Re: Safety-Kleen Corp., FLD 980 847 271
North Building Possible Contamination Assessment
Tampa Service Center, 24th Avenue and 54th Street

RE: Response to Notice of Technical Inadequacy and Revision to Confirmatory Sampling Workplan
- Safety-Kleen Corp., Tampa, Florida Facility - EPA ID No. FLD 980 847 271

ATTACHMENT A
RESPONSES TO NOTICE OF TECHNICAL INADEQUACY
SAFETY-KLEEN CORP., TAMPA, FLORIDA FACILITY
CONFIRMATORY SAMPLING WORKPLAN
EPA I.D. NUMBER FLD 980 847 271

RE: Notice of Technical Inadequacy
Safety-Kleen Corporation, Tampa, Florida Facility
Confirmatory Sampling Workplan
EPA I.D. Number FLD 980 847 271

FIGURE 2

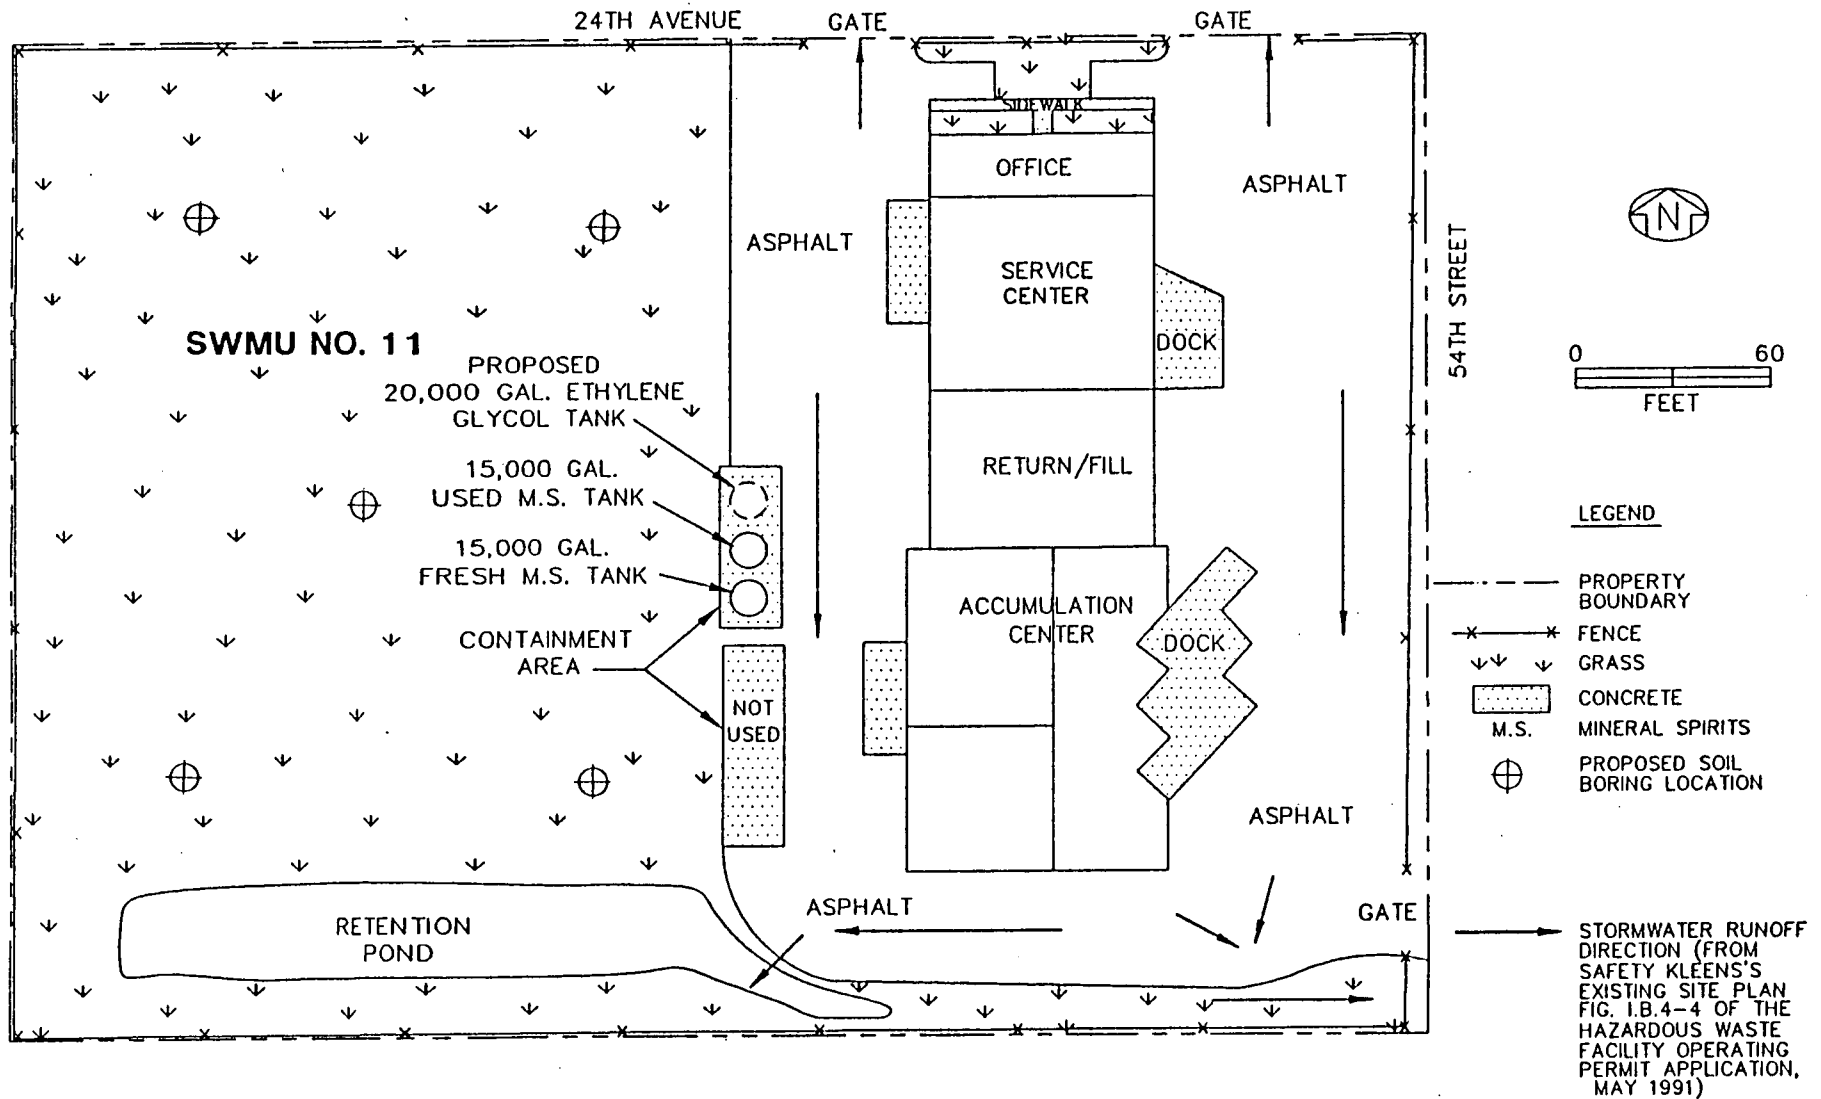
5. Page 5: VOA trip blanks must be included in the study in addition to the equipment rinse blanks.
6. Page 5, Soil Sampling: The two discharge locations have not been identified, so the soil sampling plan can not be adequately evaluated. The proposed sampling locations must be depicted on Figure 2.
